McKay Oil Corporation

RE: Lookout C Federal #8

> API: 30-005-64041 SEC9, T6S, R22E LEASE: NM-36192

PIT DESIGN AND CONSTRUCTION SPECIFICATIONS (19.15.17.11) *Pit Amendment (9/11/08)

MCKAY OIL CORPORATION -- LOOKOUT C FED #8 990' FEL & 2310' FNL, SE', Unit H, SEC9, T6S, R22E API: 30-005-64041

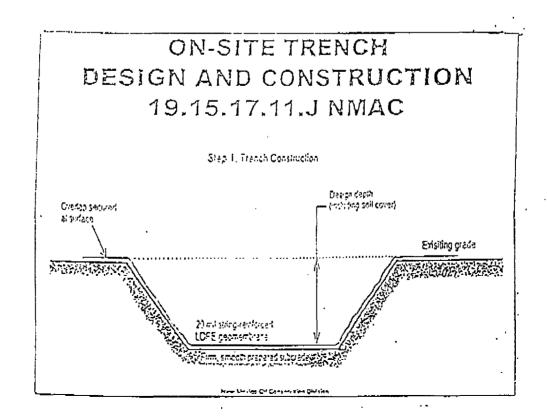
On Thursday, September 11, 2008, excavation commenced for the pit when hard rock was encountered at a depth between 4' and 6' on east side. Operator desires to amend the APD to provide for the following variances: Modify reserve pit dimensions from 60' X 60' X 8' to 60' X 80' X 4'-6'.

- 1. Any topsoil, which can sustain plant vegetation, will be bladed and piled for future rehabilitation.
- 2. The location slopes very slightly from the west to the east. Due to hard rock, pit will be dug to 6' depth on northeast corner and taper to 4' depth on the northwest corner.

- 3. The 60' X 80' pit shall be constructed and maintained so that runoff water from outside the location is not allowed to enter the pit. The berms surrounding the entire perimeter of the pit shall extend a minimum of two (2) feet above ground level. At no time will standing fluids in the pit be allowed to rise above ground level.

Moth: Verbal approval given

Pending like approval from BLM
